East Anglia ONE North and East Anglia TWO Offshore Windfarms

Applicants' Comments on Natural England's Deadline 8 Submissions

Applicant: East Anglia TWO and East Anglia ONE North Limited
Document Reference: ExA.AS-4.D9.V1
SPR Reference: EA1N_EA2-DWF-ENV-REP-IBR-001035

ID	NE Comment	Applicants' Comments
		 <p>Estimated density of red-throated divers in the Outer Thames Estuary. Adapted from Figure 2 in O'Brien et al. 2012 (windfarm boundaries are shown in red).</p>

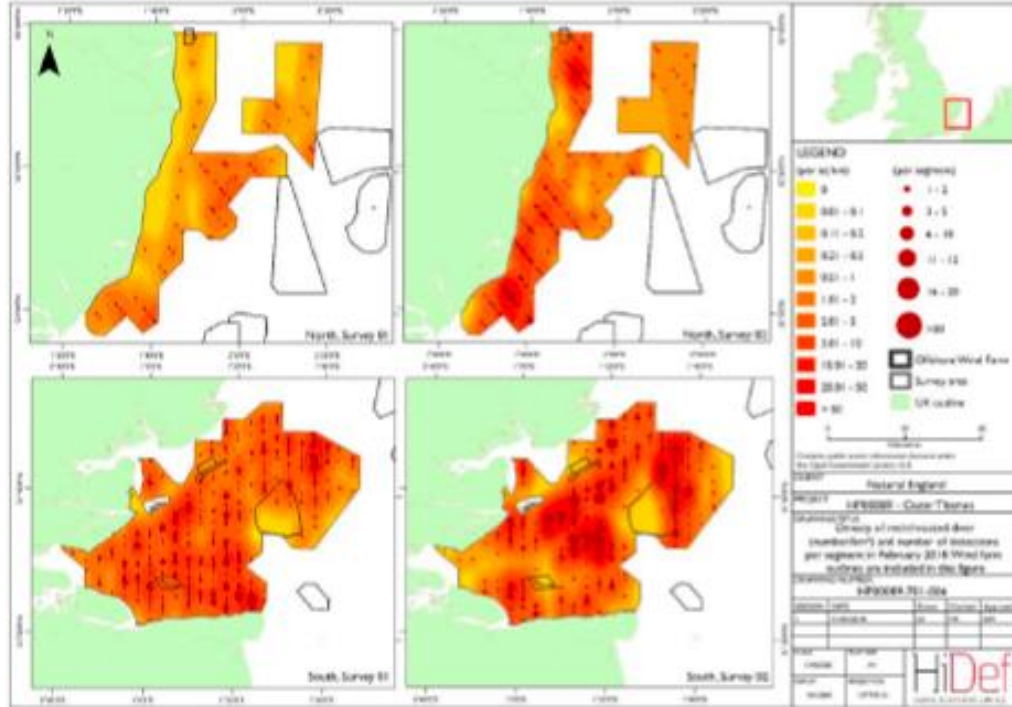
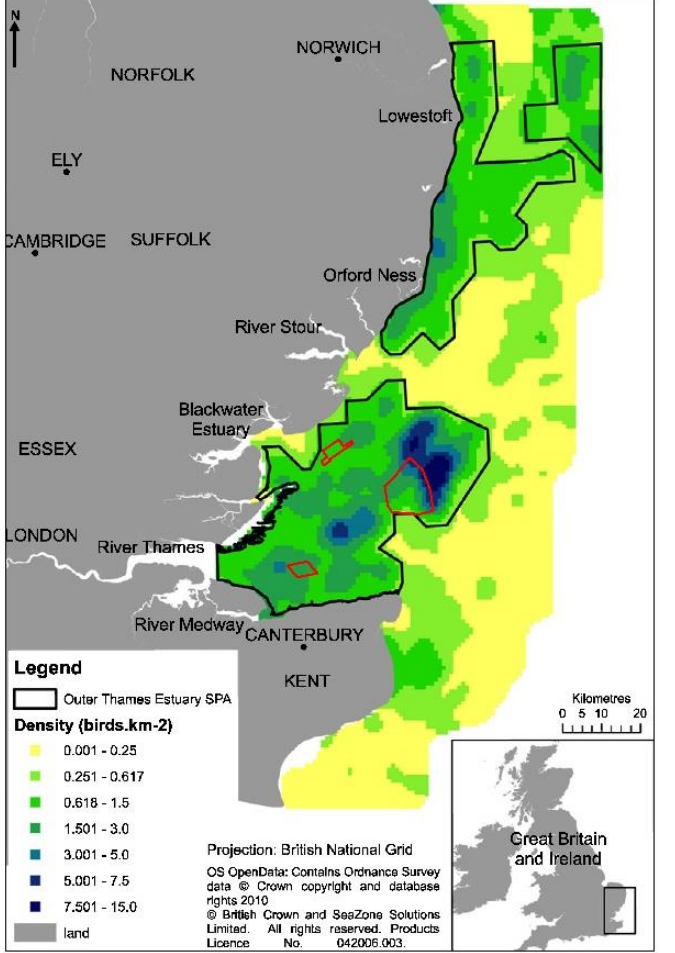
ID	NE Comment	Applicants' Comments
10	<p>g) Distribution and density</p> <p>9. It is not possible to meaningfully compare the distribution and density reported in O'Brien et al. (2012), and that presented in the most recent surveys (Irwin et al. 2019), particularly without the outlines of the windfarms for context. However, when looking at Figure 8 from Irwin et al. 2019 (see figure below) which includes densities of red-throated diver (number/km²) together with the windfarm outlines, it is possible to see the effect of existing windfarms on diver distribution.</p>	<p>In order to assist NE to compare the distribution of red-throated divers before the windfarms were constructed with those presented following construction, the Applicants have updated the red-throated diver distribution figure (Figure 2 from O'Brien et al. 2012)³ with the addition of the boundaries of the windfarms which were <u>later</u> built (the windfarm boundaries are shown in red on the figure).</p> <p>It is apparent that the distribution of red-throated divers in the lower-right panel of Figure 8 from Irwin et al. (2018), highlighted by NE as evidence of displacement from the windfarms, was in fact already evident <u>before</u> the windfarms were installed. Indeed the similarity in the distribution between the 2018 distribution in the lower-right panel of Figure 8 and the distribution in the same region in O'Brien et al. (2012) is striking, with lower density areas 'within' the windfarms and higher densities 'between' them and to the east of where London Array <u>would</u> be built.</p>

ID	NE Comment	Applicants' Comments
11	<p>10. The lower densities of RTDs within windfarm footprints is clearly demonstrated in the bottom right image in Figure 8, and the largest density of divers is equidistant from the three windfarms – London Array, Kentish Flats and Gunfleet Sands.</p>	<p>As noted above, the apparent displacement effect due to the windfarms was in fact present in advance of the windfarms being constructed and it is therefore not appropriate to ascribe the 2018 distribution of red-throated divers to windfarm displacement, with other factors in the environment already influencing the bird's distribution.</p> <p>It should be stressed that the Applicants are not suggesting that windfarms have no effect on this species, but rather their influence should be viewed in the context of existing distributions and not overstated. This was the rationale for the spatial modelling undertaken by the Applicants, and the use of counterfactual outputs which incorporate existing distributions.</p>
